DEPARTMENT OF AGRICULTURE
Rural Utilities Service
7 CFR Part 1755
RUS Standard for Service Installations at Customer Access Locations
AGENCY: Rural Utilities Service, USDA.
ACTION: Final rule.

SUMMARY: The Rural Utilities Service (RUS) amends its regulations on Telecommunications Standards and Specifications for Materials, Equipment and Construction, by rescinding RUS Bulletin 345-52, RUS Standard for Service Entrance and Station Protector Installations, PC-5A, and codifying the revised standard in the Code of Federal Regulations (CFR) as the RUS Standard for Service Installations at Customer Access Locations. The revised standard updates the installation methods used for installing aerial and buried service drops, network interface devices, fused primary station protectors, and protected building entrance terminals at customer access locations as a result of technological advancements made in

Response: Based on the respondent's comments, RUS decided to review all the figures and construction drawings in §§ 1755.500 through 1755.510 for editorial and technical correctness. As a result of RUS's review the following actions concerning the figures and construction drawings were take

FIGURE 3
CABLE ENTRANCES AND RUNS IN BUILDINGS

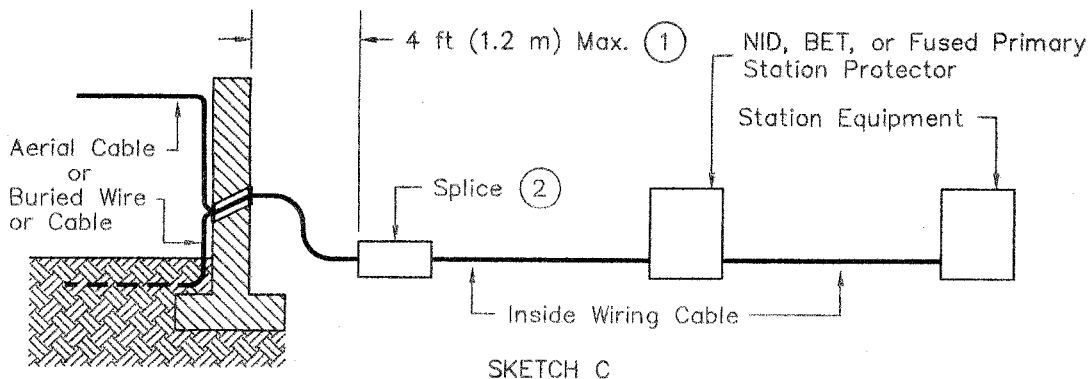
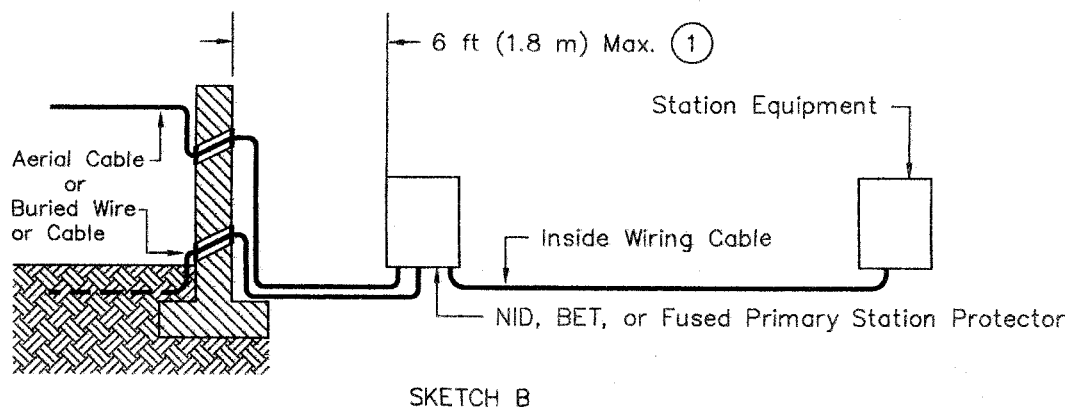
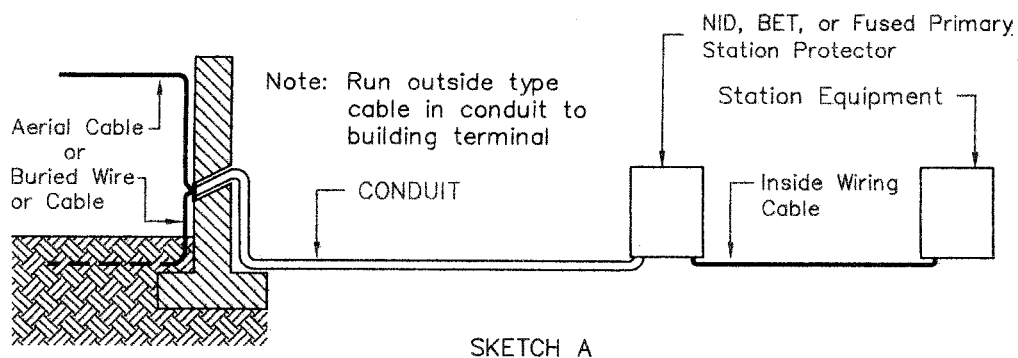
2. Figures 3 and 8 have been revised to reference the 1999 issue of the *NEC*® instead of the 1996 issue of the *NEC*®, which is no longer in effect.

FIGURE 9

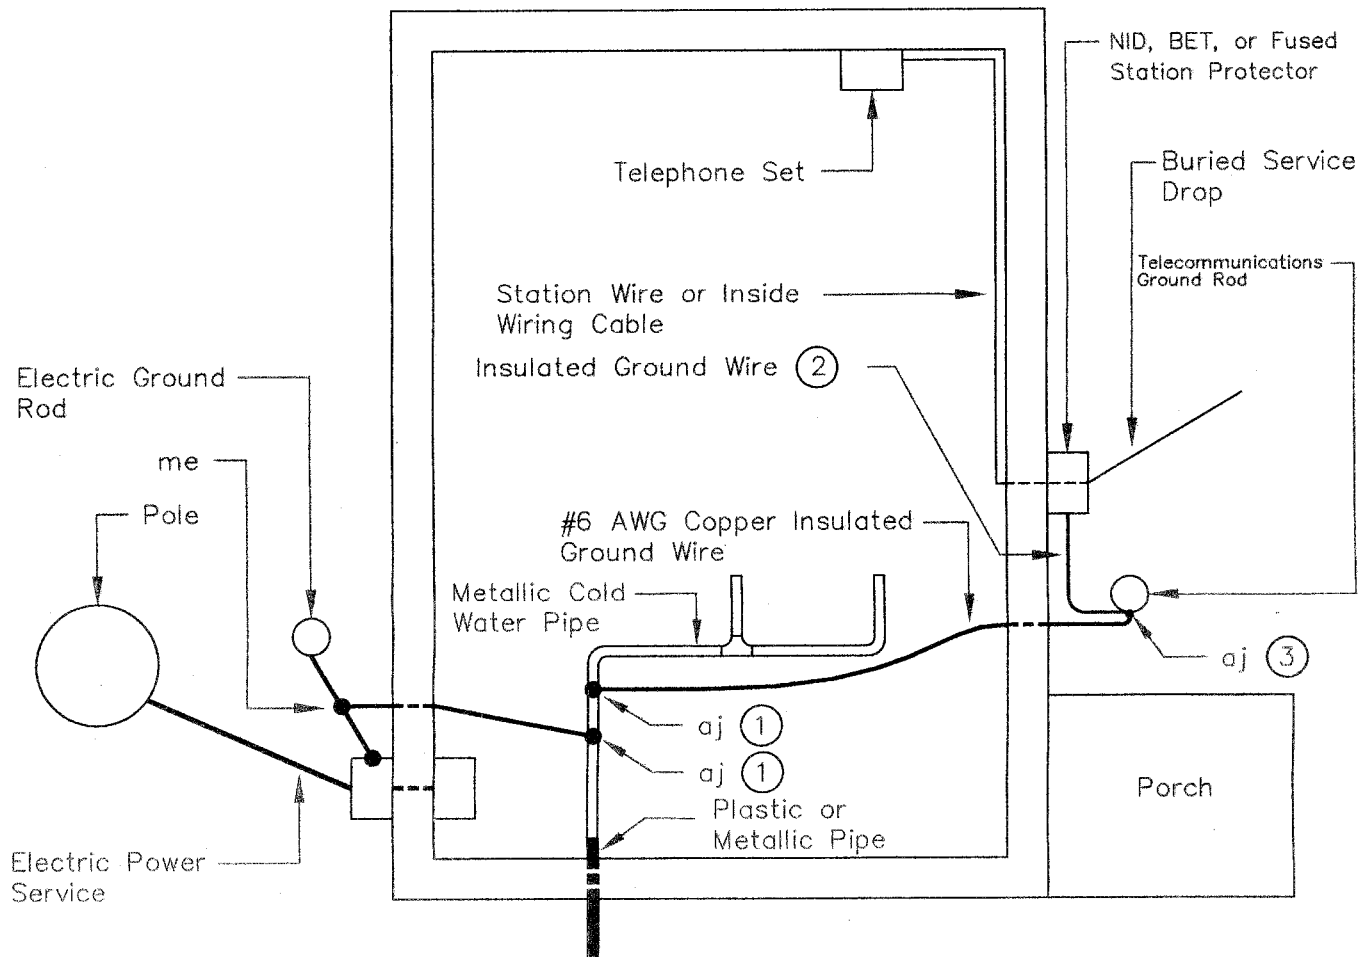
3. Figures 9, 17, and 18 have been revised to indicate generic telecommunications service wire installations at customer access locations instead of specific telecommunications service wire installations at customer access locations because it is impossible for RUS to predict the number of telecommunications service circuits requested by customers. This was accomplished by replacing the references to the "#12 AWG copper insulated ground wires" which specify only two pair telecommunications services with generic references to "copper insulated ground wires" and "associated notes" indicating that § 1755.508(v), Table 5, should be used to determine the correct ground wire conductor size suitable for the installations based on the number of telecommunications circuits installed at customer access locations.

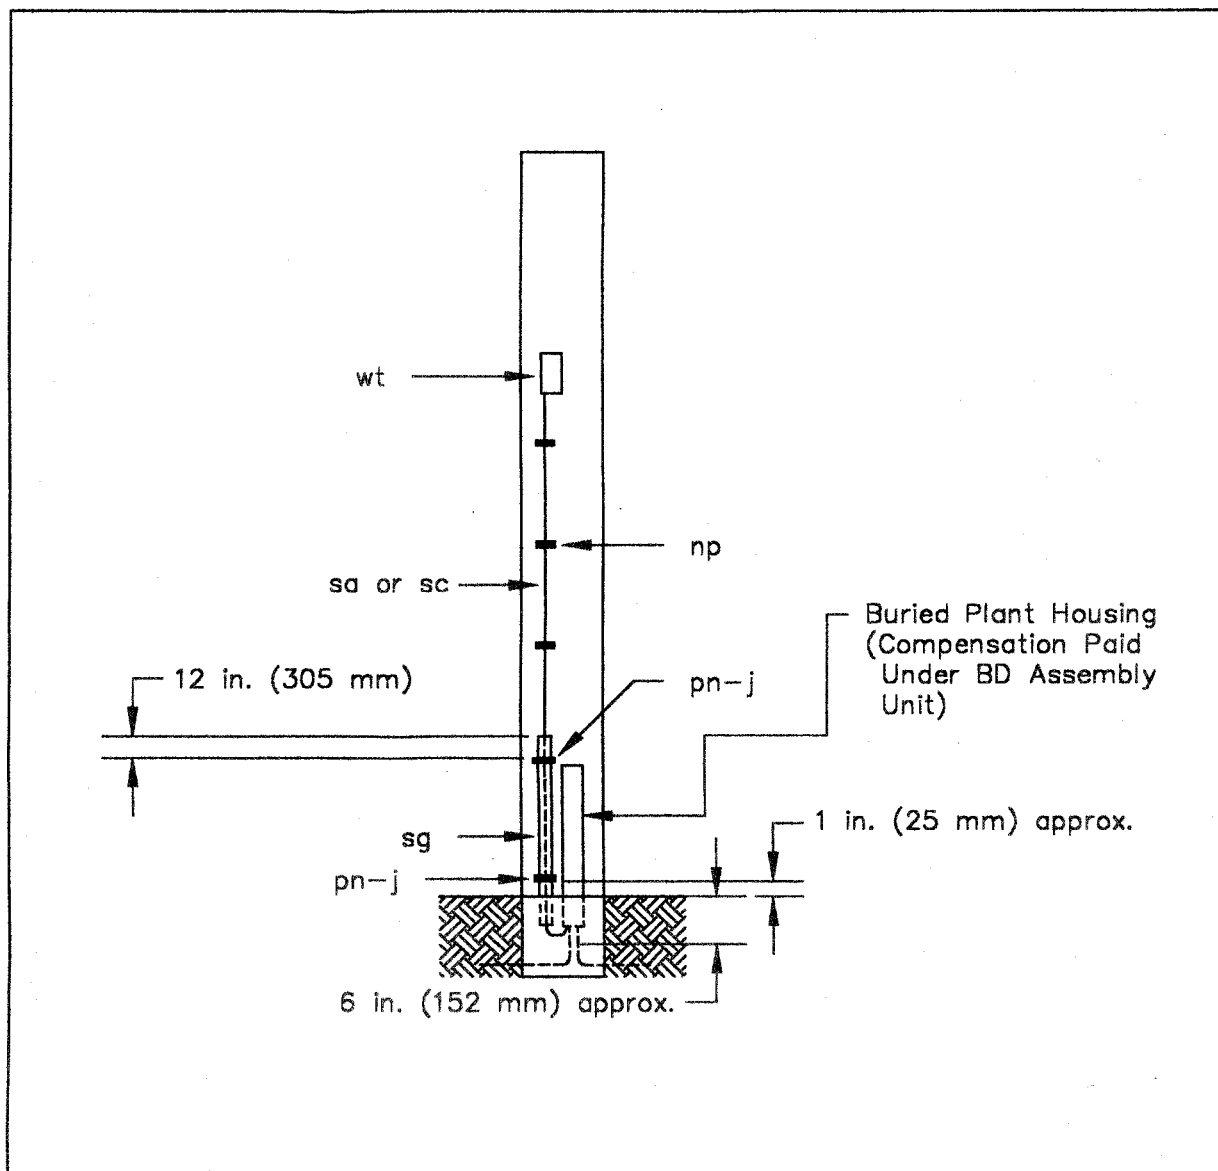
7. The "BM50 Assembly Unit Drawing" is being inserted to replace Construction Drawing 912 in § 1755.510. The reason for this change is attributed to current installation practices. Aerial service wires (from buried cables) are installed in accordance with information provided in the BM50 Assembly Unit Drawing

not the 912 Construction Drawing. The major difference between the BM50 Assembly Unit Drawing and the 912 Construction Drawing is that the BM50 drawing eliminates the aerial service installation information from the drawing and indicates that the buried plant housing is paid under the buried plant housing assembly unit (BD).

ITEM	MATERIAL	NO. REQ'D
am	Guard, buried service (including fasteners)	1
RURAL TELECOMMUNICATIONS CONSTRUCTION PRACTICES BURIED SERVICE GUARD		
Scale: NTS		March 2001
		BM83

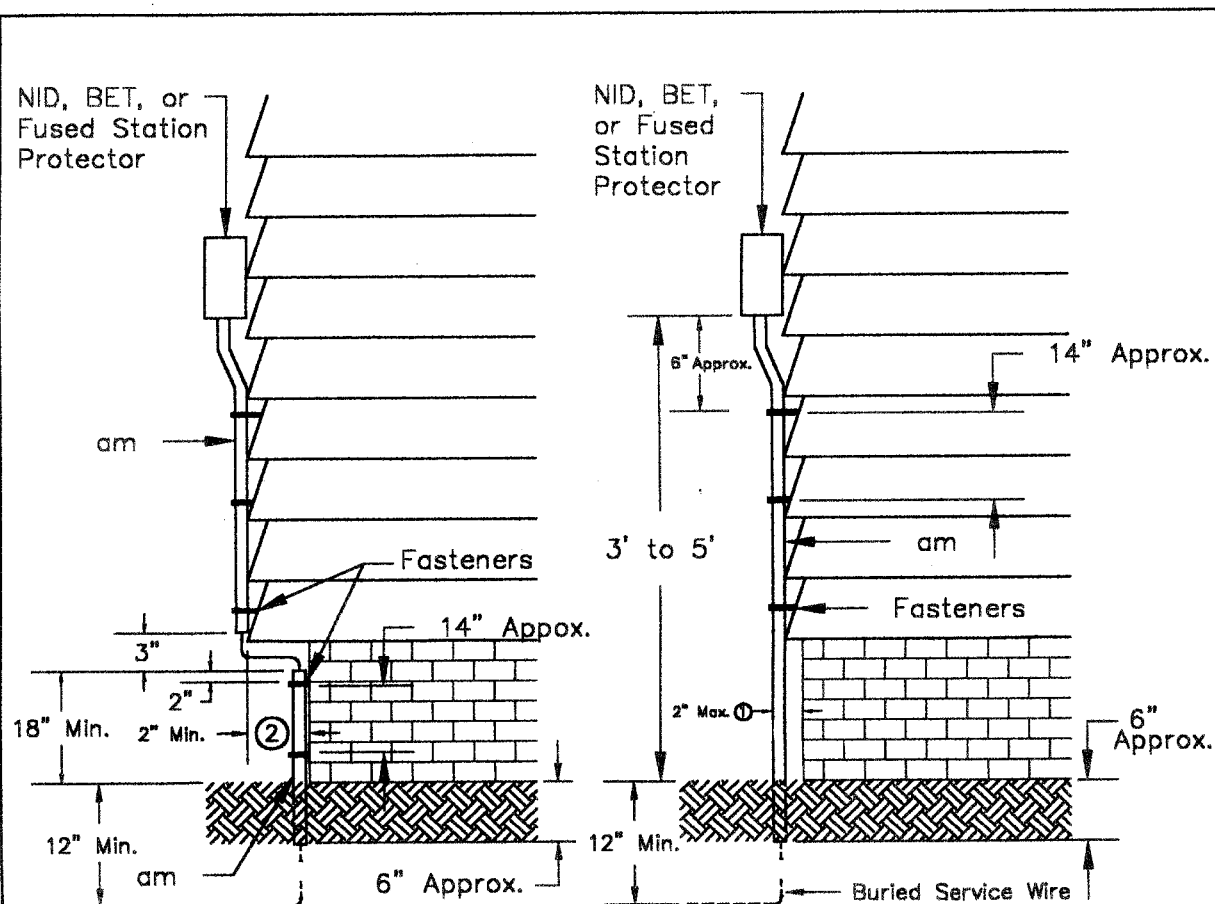
The same respondent recommended that Note 2 of the BM83 Assembly Unit Drawing in § 1755.510 be modified to allow the optional installation of a flexible service guard when an obstruction of greater than 2 in. (51 mm) is encountered instead of requiring two service guards.

Response: After much discussion and consideration, RUS agrees with the comment and is modifying Note 2 of the BM83 Assembly Unit Drawing in § 1755.510 to allow the optional installation of a flexible conduit when obstructions of greater than 2 in. (51 mm) are encountered. The revised Note 2 of the BM83 Assembly Unit Drawing will read as follows: "Where an obstruction of greater than 2 in. is encountered, the buried service guard (item am) shall be divided as shown (from the NID, BET, or fused protector to the obstruction, and from 3 in. below the obstruction to 6 in. below the ground). In lieu of divided service guards (item am), a continuous flexible conduit may be used from the NID, BET, or fused protector to 6 in. below the ground."

RURAL TELECOMMUNICATIONS CONSTRUCTION PRACTICES		
AERIAL PLASTIC CABLE DETAILS OF WIRE		
CONNECTIONS TO FILLED TERMINAL BLOCKS		
Scale: NTS		March 2001
		312-1

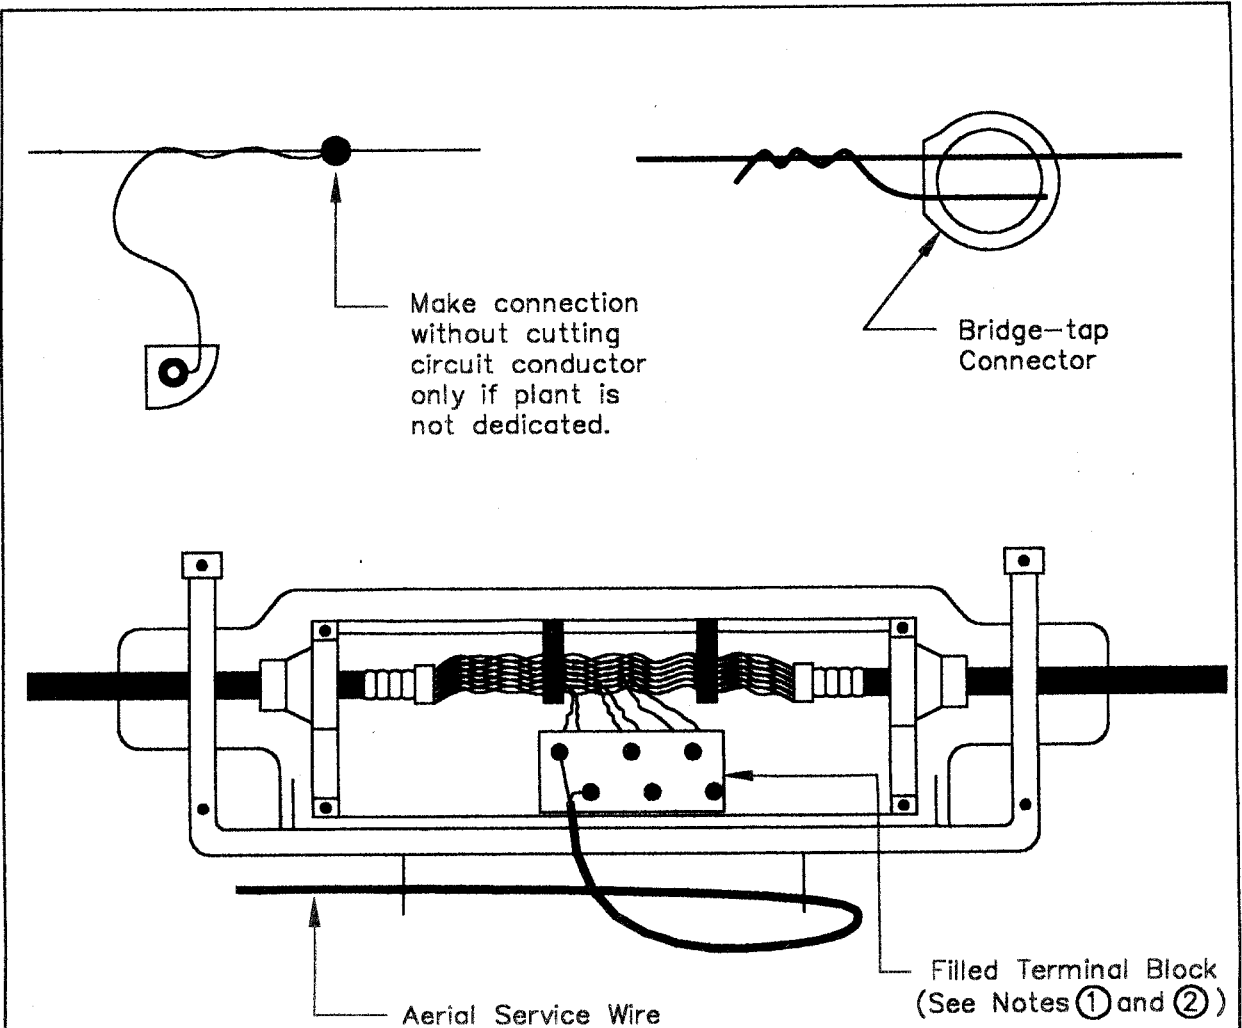
The final comment from the same respondent questioned the editorial and technical correctness of Construction Drawings 312-1, 501-1, 501-2, 702, 958, and 962 in § 1755.510.

4. Construction Drawing 312-1 in § 1755.510 is being changed by adding the respondent's recommended language of "only if plant is not dedicated" to the proposed language concerning one of the methods of terminating the lead-out wires of terminal blocks to distribution cable conductors. This new language will read as follows: "Make connection without cutting circuit conductor only if plant is not dedicated."
